Maserati

Rapid Update 713

Grecale Multiple Software Updates

DATE: MARCH 14, 2024

RFHM (Radio Frequency HUB Module)

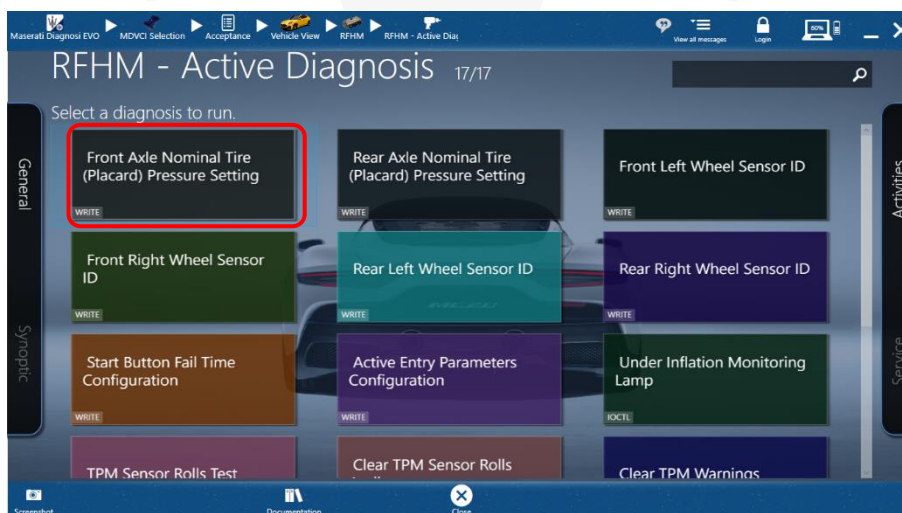
This update is essential to prevent the occurrence of a false TPMS (Tire Pressure Monitoring System) warning indication. In specific situations, the front tire pressures might erroneously appear in yellow on the cluster display, even when the actual tire pressures meet or exceed the specified values. This problem stems from an incorrect internal calculation related to the hexadecimal conversion between psi and bar. It's crucial to note that this update does not alter the tire pressure values as stated in the owner manuals and technical documentation.

- h. From ECU View, select **RFHM – ECU programming**.
- i. After ECU programming, perform **BCM – Procedures – PROXI Alignment**.
- j. Clear DTCs.

IMPORTANT for 19" tires only:

- k. Select **RFHM – Active diagnosis – Front Axle Nominal Tire (Placard) Pressure Setting**:

- l. Insert **31** in the text box and click on **Execute** to set the new value.
